**Economic Commission for Europe****Inland Transport Committee****World Forum for Harmonization of Vehicle Regulations****Working Party on Lighting and Light-Signalling****Eighty-third session**

**UN Regulation No. 48 (Installation of lighting and light-signalling devices):****Proposals for new series of amendments to UN Regulation No. 48****Proposal for a new [0x] series of amendments to UN Regulation No. 48****Submitted by the Informal Working Group on Simplification of Lighting and Light-Signalling Regulations\***

6.2.6.1.2. **Vertical inclination limits of the cut-off**

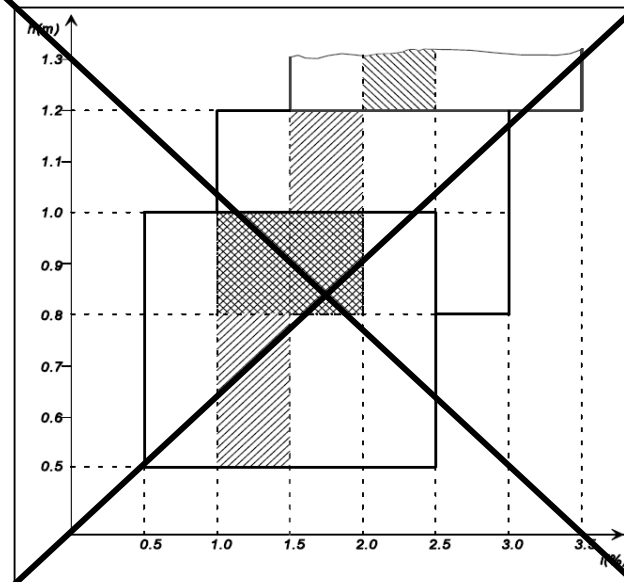
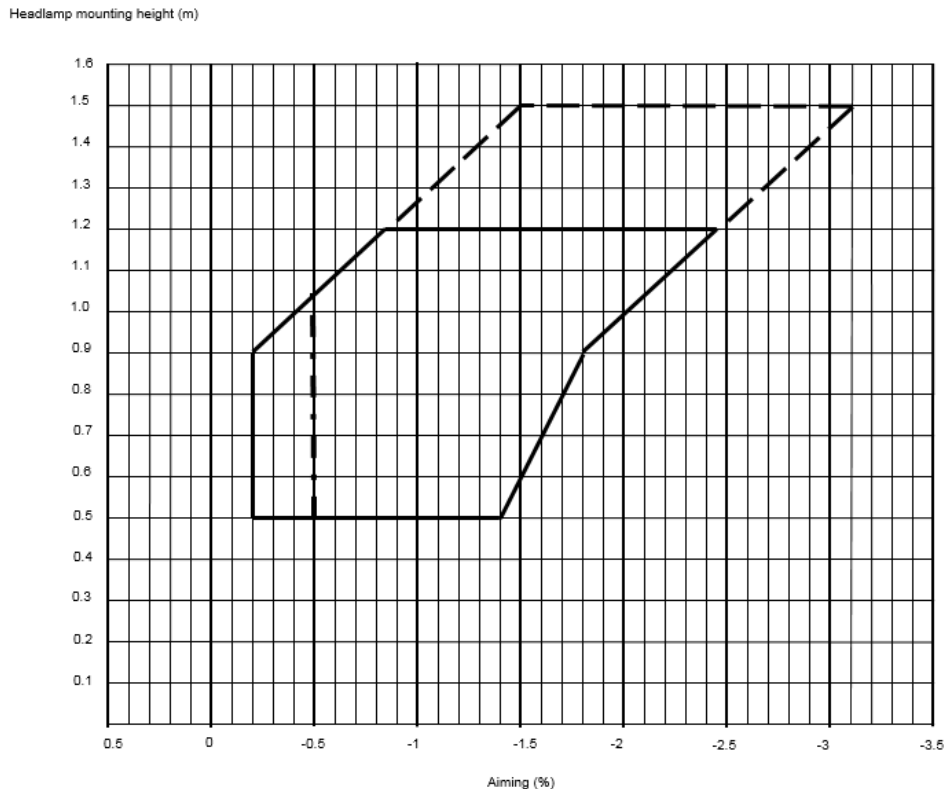
Depending on the mounting height in meters (h) of the lower edge of the apparent surface in the direction of the reference axis of the **passing beam (dipped-beam) headlamp**, measured on the unladen vehicles, the vertical inclination of the cut-off of the **passing beam (dipped-beam)**, **starting from the initial downward inclination value set by the vehicle manufacturer as prescribed in paragraph 6.2.6.1.1.**, shall under all the static conditions of Annex 5, remain between the following limits and the initial aiming shall have the following values: **under all the static loading conditions of Annex 5:**

<i>Mounting height h [m]</i>	<i>Upper inclination limit [per cent]</i>	<i>Lower inclination limit [per cent]</i>
<b><math>0.5 \leq h \leq 0.9</math></b>	<b>-0.20</b>	<b>-1.40 to -1.80*</b>
<b><math>0.9 &lt; h \leq 1.2</math></b>	<b>-0.20 to -0.85*</b>	<b>-1.80 to -2.45*</b>
<b><math>1.2 &lt; h \leq 1.5^{**}</math></b>	<b>-0.85 to -1.50*</b>	<b>-2.45 to -3.10*</b>

The above limits and the initial aiming values are summarized in the diagram below.

Model A

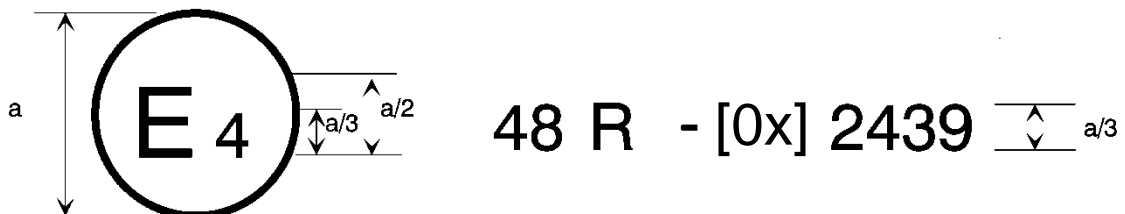
The above approval mark affixed to a vehicle shows that the vehicle type concerned has, with regard to the installation of lighting and light-signalling devices, been approved in the Netherlands (E 4) pursuant to UN Regulation No. 48 as amended by the [0x] series of amendments. The approval number indicates that the approval was granted in accordance with the requirements of UN Regulation No. 48 as amended by the [0x] series of amendments.

Model B

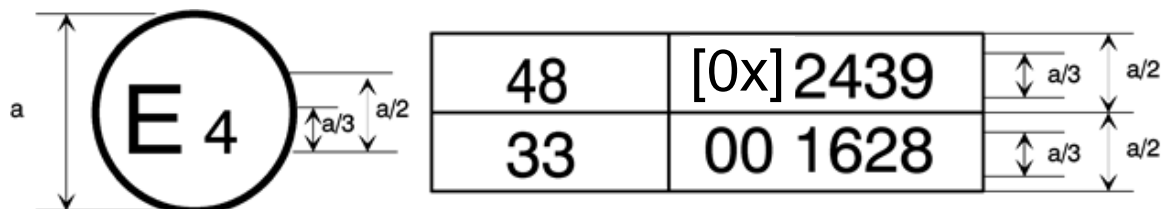
The above approval mark affixed to a vehicle shows that the vehicle type concerned has been approved in the Netherlands (E 4) pursuant to UN Regulation No. 48 as amended by the [0x] series of amendments and UN Regulation No. 33.<sup>1</sup> The approval number indicates that, at the dates when the respective approvals were given, UN Regulation No. 48 was amended by the 0x series of amendments and UN Regulation No. 33 was still in its original form.”
